UNITED STATES PATENT AND TRADEMARK OFFICE

10/552,532

Office Action Summary	Application No. 10/552,532	Applicant(s) HAYASHI, YASUSHI	
	Examiner AMENE S. BAYOU	Art Unit 3746

DETAILED ACTION

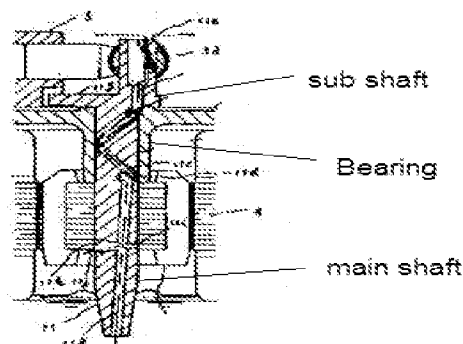
- Electric compressor ,in figure 1 and 2 ,comprising :a single phase induction motor (4) formed of stator and rotor
- A compressing mechanism (5) driven by the motor (4)
- A hermetic container (2) for accommodating the motor (4) and the compressing mechanism (2) and for pooling lubricant (7)
- A shaft having a main shaft and sub shaft (shown below)

- A cylinder (5) for forming a compressing chamber
- A bearing (shown below) for supporting the main shaft

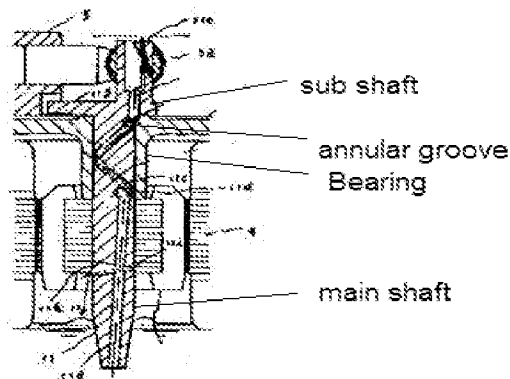
- A forward leading groove (11c) engraved on an outer wall of the main shaft and having a first end communicating with the centrifugal pump (11a) and a second end communicating with an annular lubricant groove (shown below) provided on an upper end of the bearing. Please also note that the applicant admitted the annular lubricant groove as prior art in page 1 line 24.

- A vertical hole (11f) bored in the sub shaft and having a first end communicating with the annular lubricant groove and a second end opening into the hermetic container .Nobuo et al.' 108,however fail to disclose the following limitation which is taught by Goodnight'561:
- Main shaft comprising a first section (32) having a first diameter and a second section (46) having a second diameter smaller than the first diameter, reverse leading groove (44) having a lead directing in an opposite direction to that of the forward leading groove (42),and having a first end ,in figure 7-9 and columns 3,line 39-50 and column 7,lines 7-11 . However,Nobuo et al.' 108 in view of Goodnight'561fail to disclose the following limitation which is taught by Choi '724:

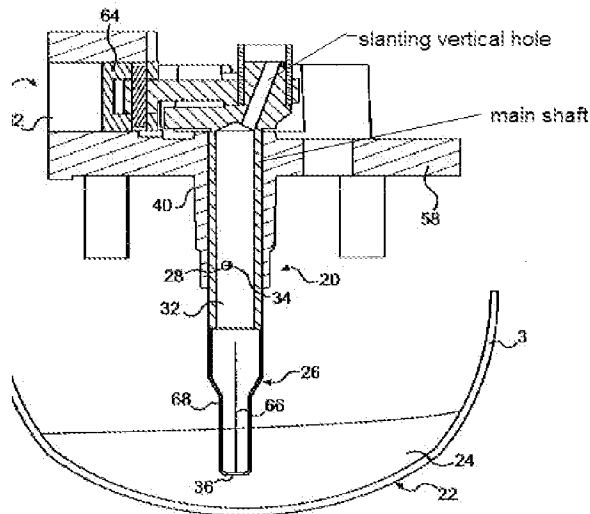
Goodnight'561 discloses:

- Lead of the reverse leading groove is greater than that of the forward leading groove in column 7, lines 10-11 and line 35-38.
